R E M A R K S

Claims 1-5, 9 and 11-15 are now in this Application, and are presented for the Examiner's consideration.

Objection to Drawings

Fig.1

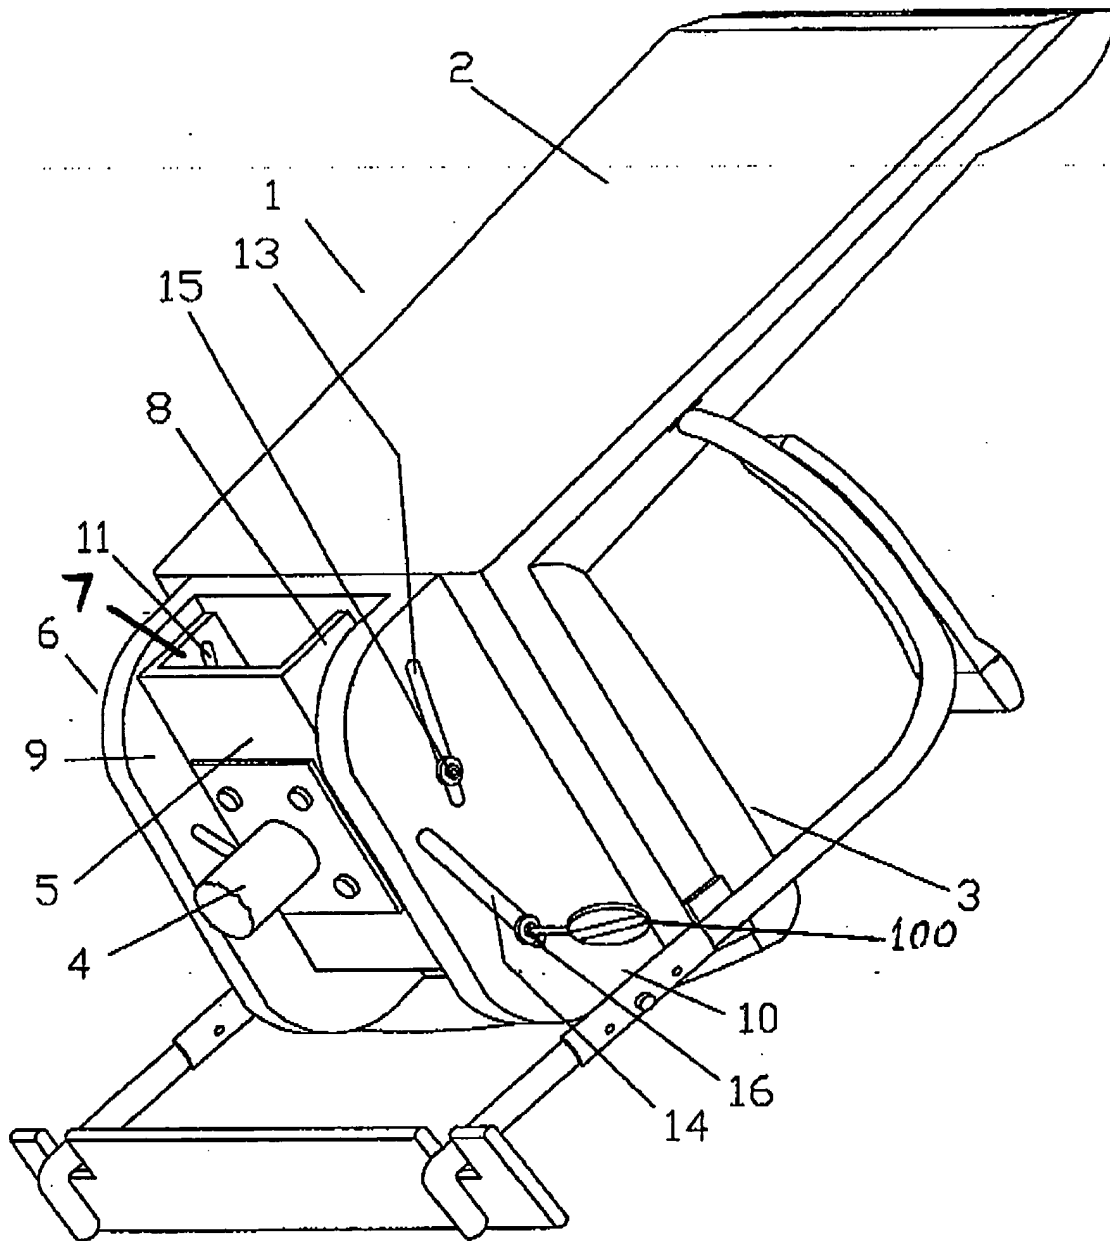
The lever of claim 9 is shown in Figs. 1 and 5, and has been labeled in Figs. 1 and 5 by numeral 100. The specification has been amended at page 3, line 23.

In addition, Fig. 1 was objected to on the ground that element 16 appears to have another element extending from it, and it is unclear what this element is. Element 16 is the shaft in slot 14. See page 2, lines 22-24. There is no element extending from shaft 16 in Fig. 1. It is submitted that the confusion arose because the lead line for shaft 16 was not extended sufficiently far, and therefore ended at the end of slot 14, rather than continuing the small distance to shaft 16.

In this regard, the lead line for element 16 has been extended to point to shaft 16, rather than the end of slot 14.

The enclosed Replacement Sheet and an Annotated Sheet Showing Changes to Fig. 1 also make this change.

Fig.5

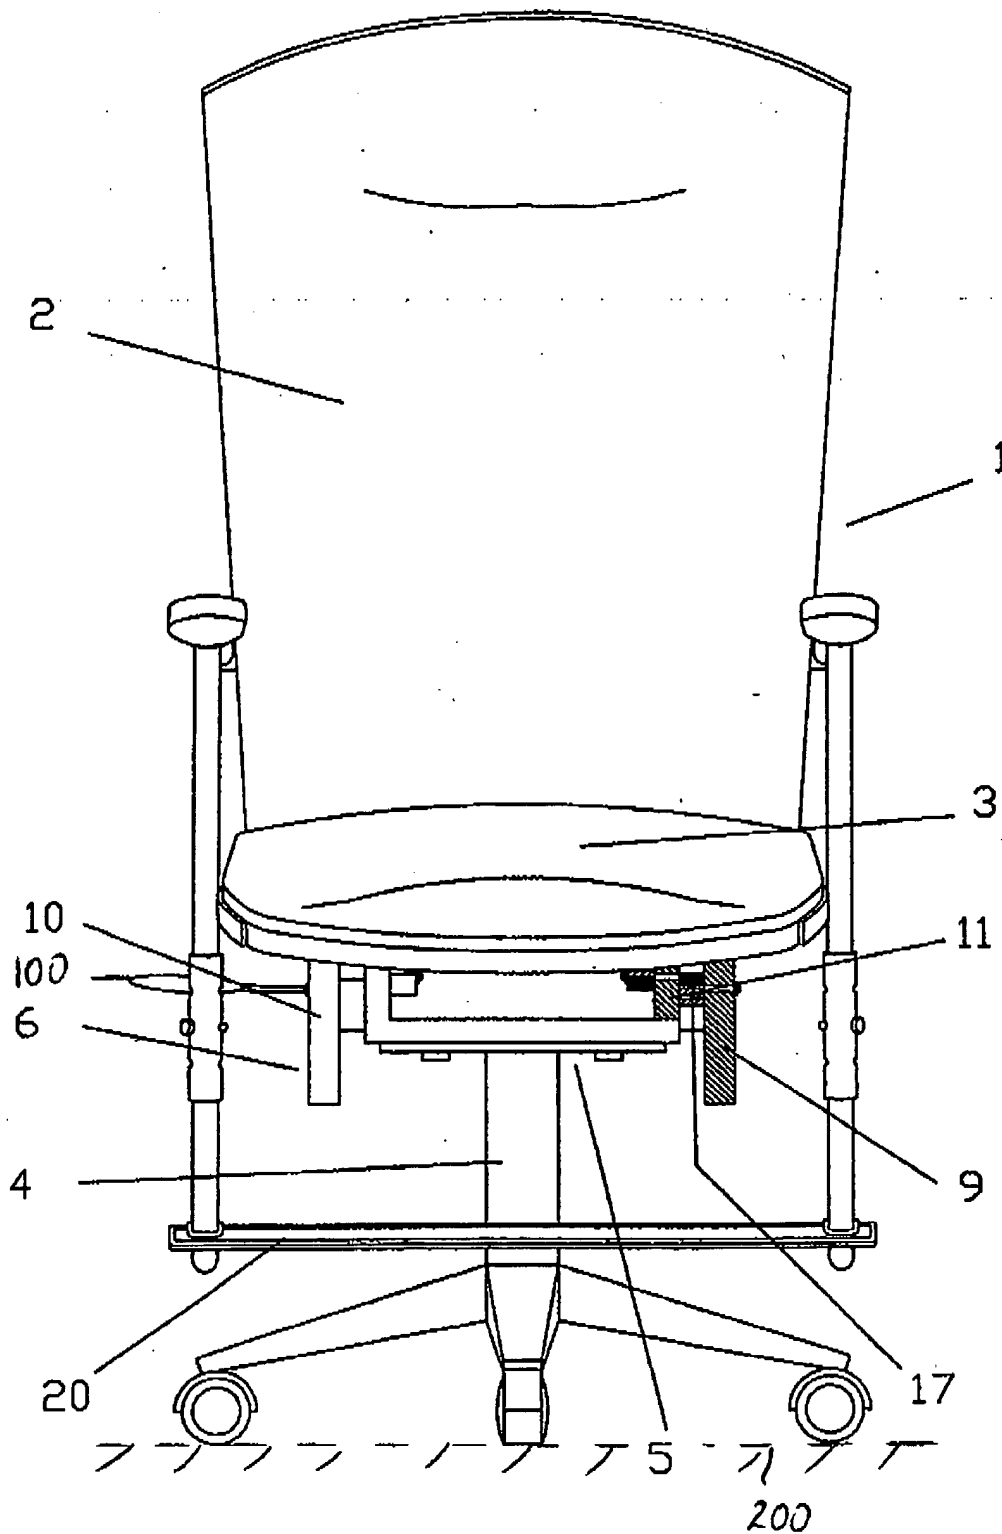
The ground surface of claim 1 has been added to Fig. 5, and labeled by numeral 200. The specification has been amended at page 2, line 16.

Also enclosed is a Replacement Sheet and an Annotated Sheet Showing Changes to Figs. 1 and 5.
